**TOWN OF WINTER PARK
PLANNING COMMISSION
Tuesday, April 9, 2024 8:00 AM**

TO Planning Commission
FROM Hugh Bell, Planner
THROUGH James Shockey, AICP, Community Development Director
DATE April 9, 2024
RE Exemption Plat – 265 Lake Trail – Amended Lot 4, Elk Run of Winter Park Subdivision,
Filing 1 (PLN24-015)

TO Planning Commission
FROM James Shockey, AICP, Community Development Director
DATE April 9, 2024
RE PUBLIC HEARING: Major Site Plan – 820 Ski Idlewild Road – Idlewild Park – Tract A, Rendezvous at Winter Park Sub Ex No. 2 and Tract A, Idlewild Sub Ex No. 1 (PLN23-115)

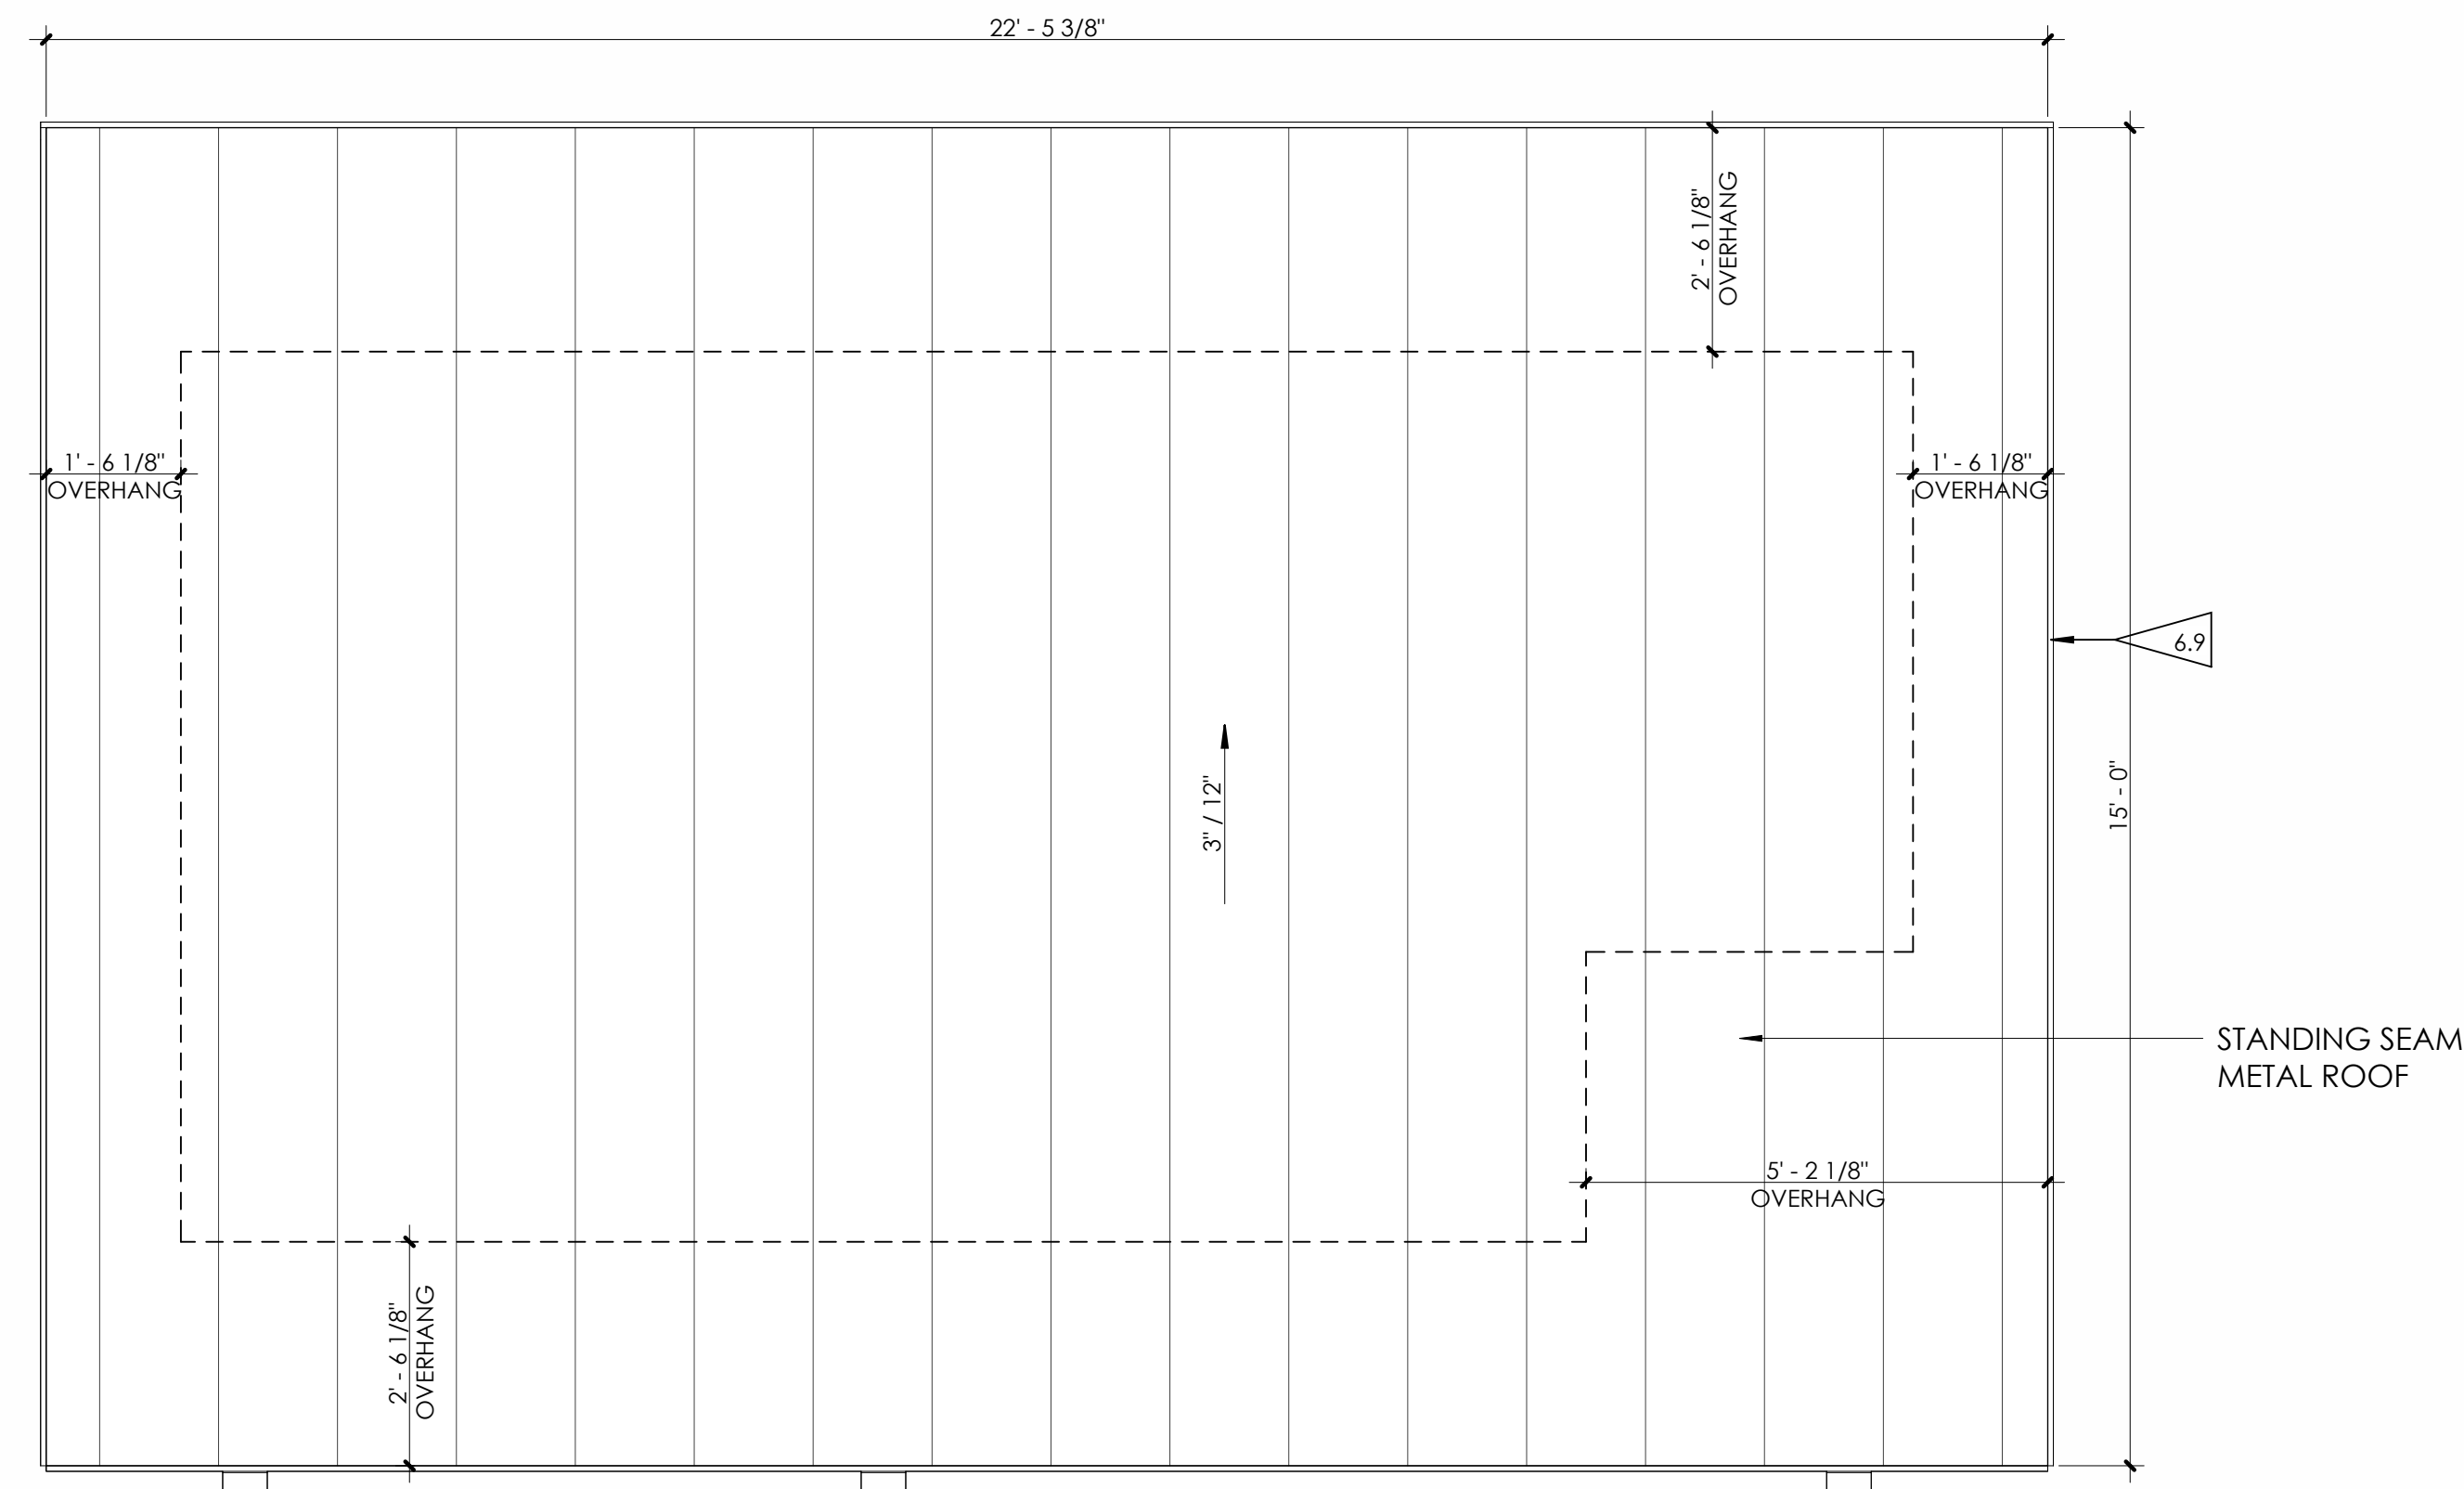
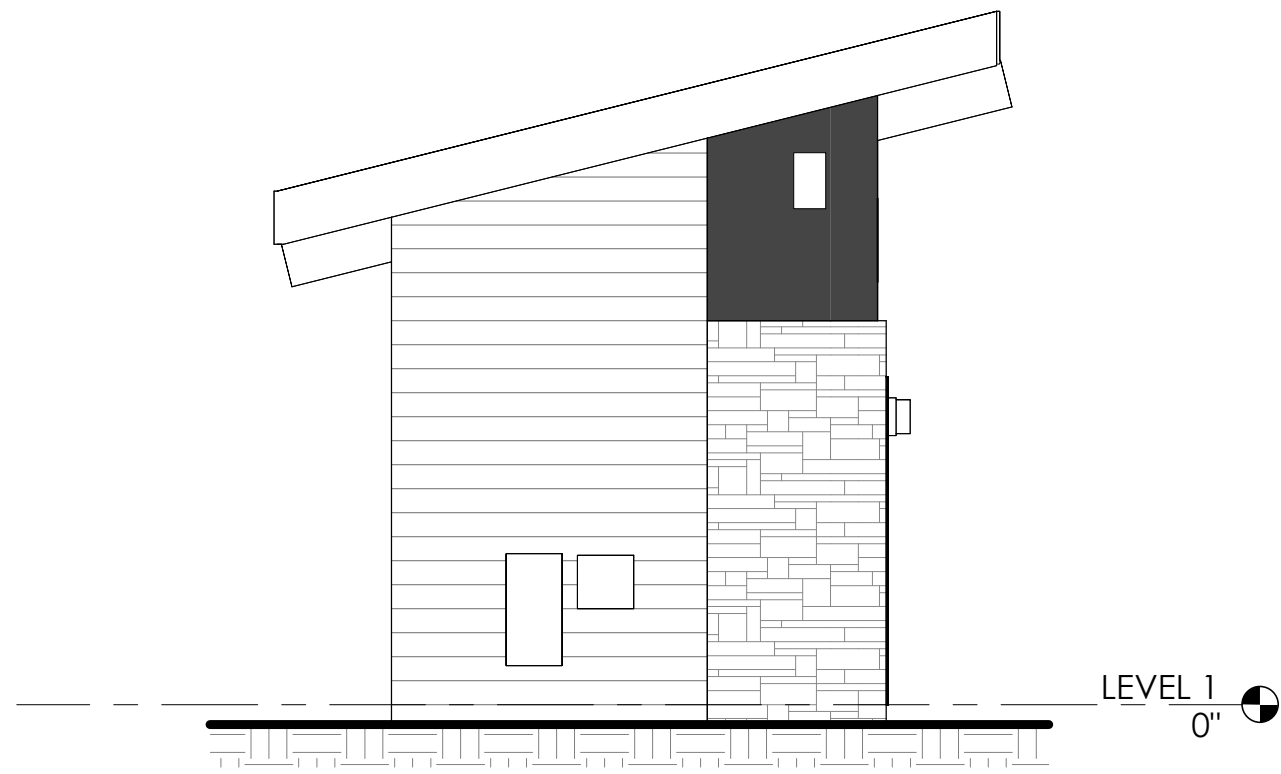
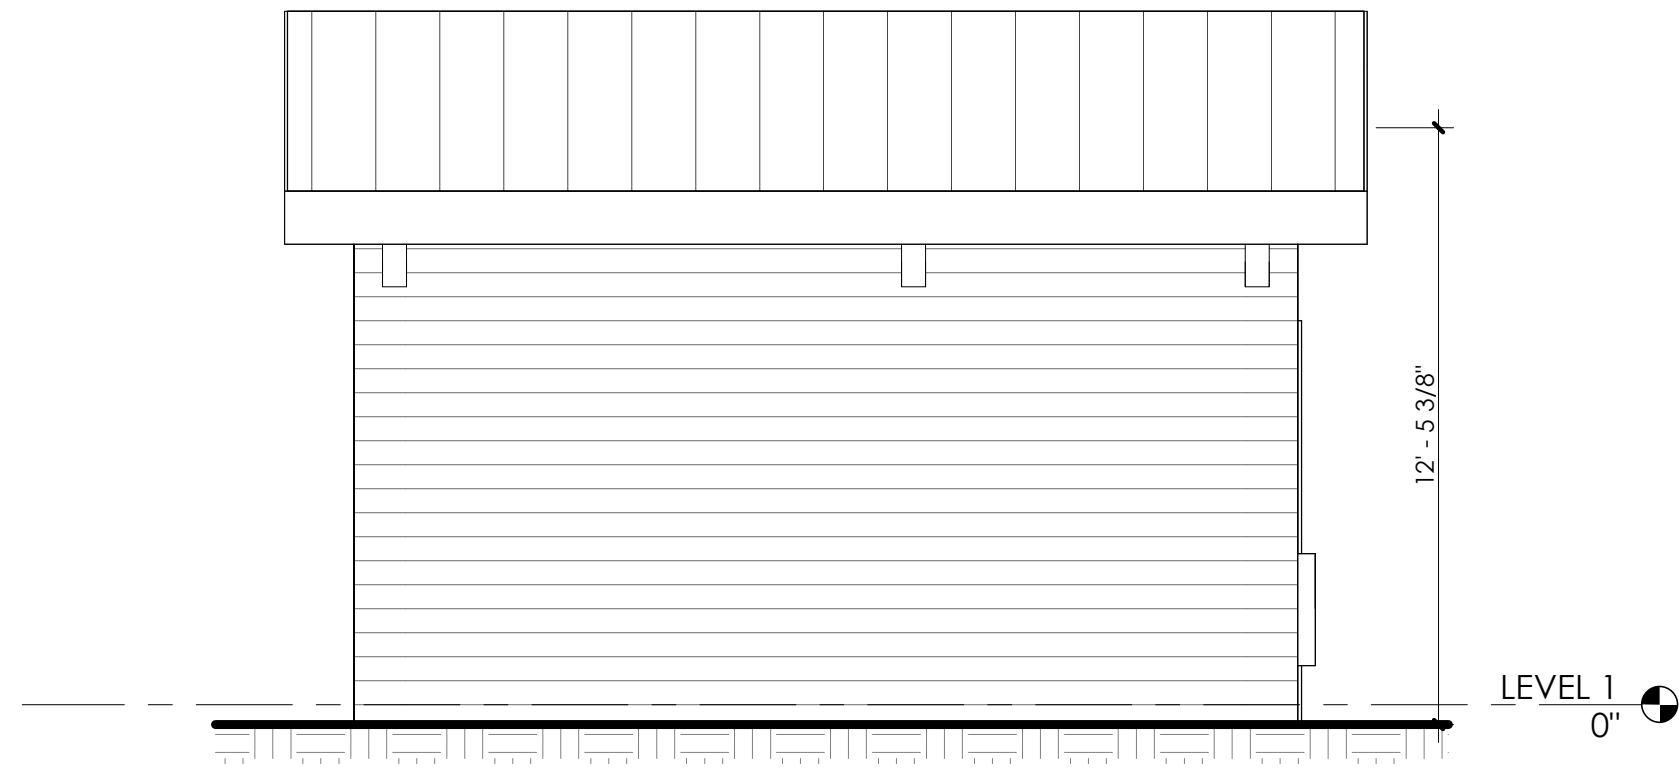
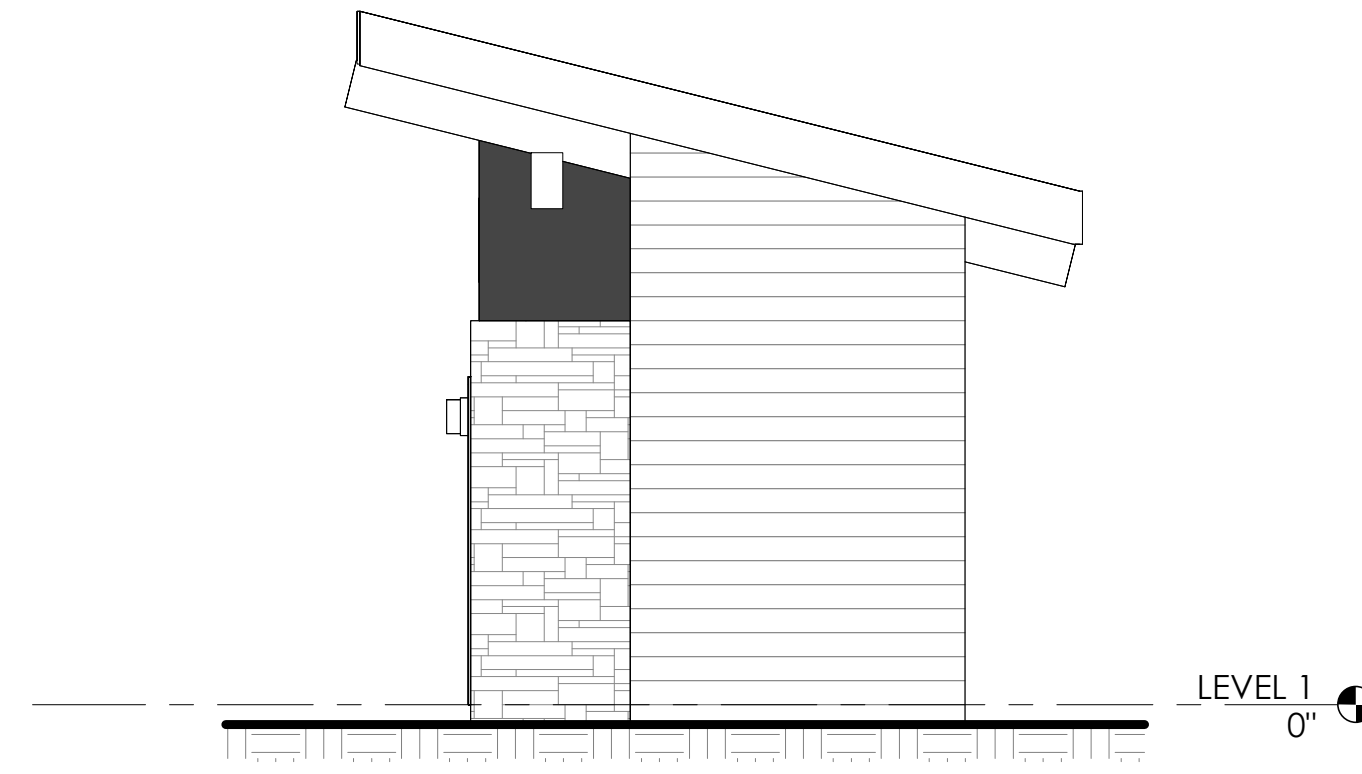
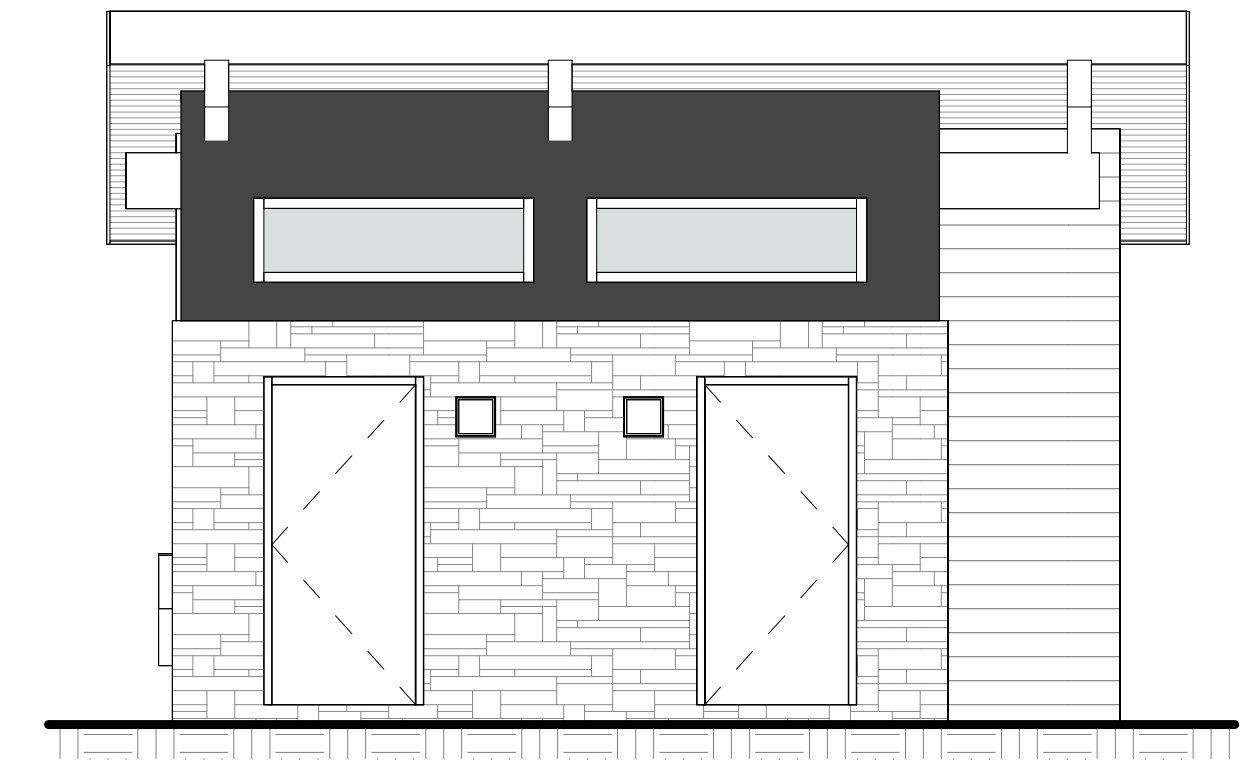
N/A. PA-4 has no building height limit. However, staff needs to measure building height to verify heights match between this Major Site Plan Application and the forthcoming Building Permit Application. Existing and proposed grades are not indicated on building elevations so staff cannot properly measure building height.

- Applicant shall submit building elevations showing existing and proposed grades so staff can properly measure building height.

4. Applicant shall submit building elevations showing existing and proposed grades so staff can properly measure building height.
5. No site clearing shall be permitted until the Building Division has verified the Pre-Disturbance Checklist has been implemented on the site.
